Determination 2011/049

Regarding the refusal to issue code compliance certificates for alterations to a house at 20 Lambley Road, Titahi Bay, Porirua

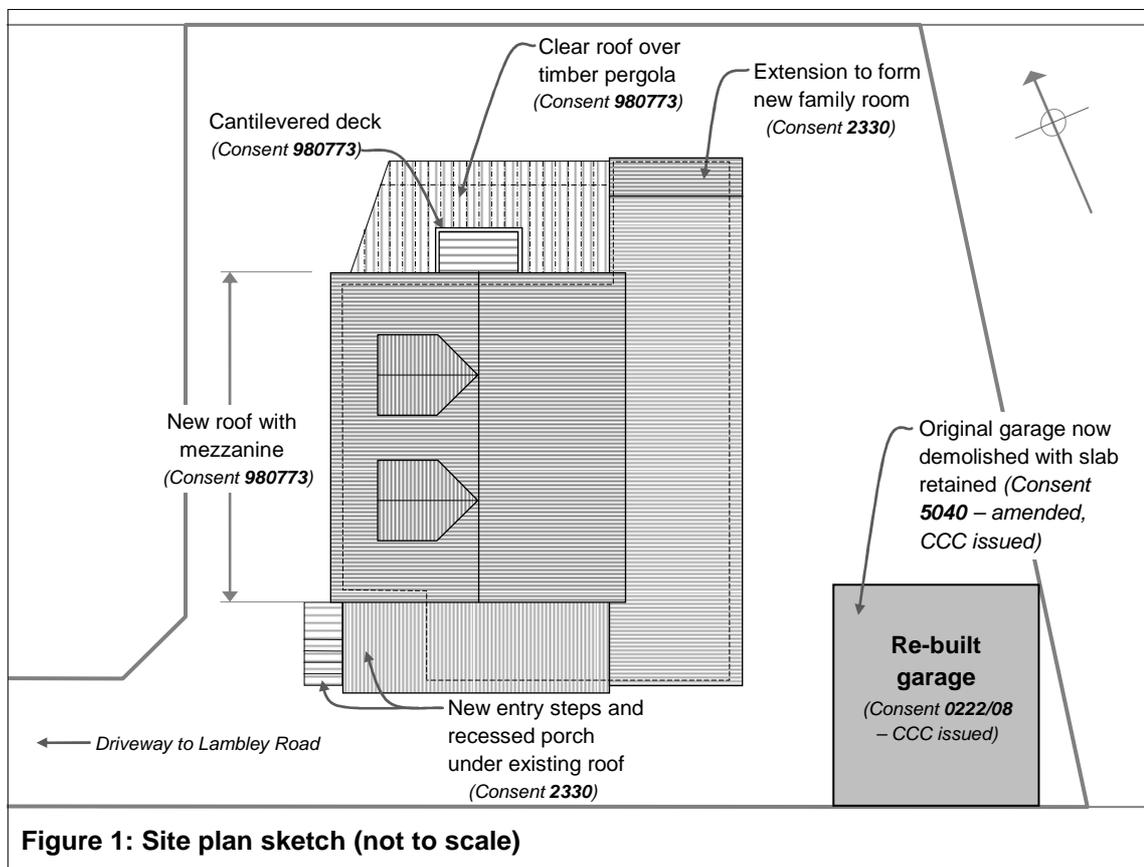
2.1 The building work consists of alterations to a detached house situated on the rear section of a gently sloping sub-divided site. The coastal site is exposed to the south in a very high wind zone for the purposes of NZS 3604⁴. The alterations to the house are indicated in the following sketch:

- demolition of the front west entry porch
- new entry steps and a recessed entry porch at the southwest corner under the existing lean-to roof
- extension of the north end of the east lean-to and interior changes to form:
 - a new kitchen/family room in the north east corner
 - a new bathroom.

- the replacement of the original gable roof with a 37° pitch gable roof
- two west-facing dormer windows and windows in gable ends
- a 3.6m deep mezzanine above the north bedrooms, with access via a ladder.

- glazed doors in lieu of north upper gable end window and a small deck added
- a staircase to the mezzanine in lieu of a ladder
- a door removed and opening widened between dining and living rooms
- windows replaced with glazed doors to dining room and north bedroom
- addition of a clear-roofed timber pergola to northwest corner
- addition of a window to east wall of entry porch
- replacement of original timber window sashes with aluminium sashes.
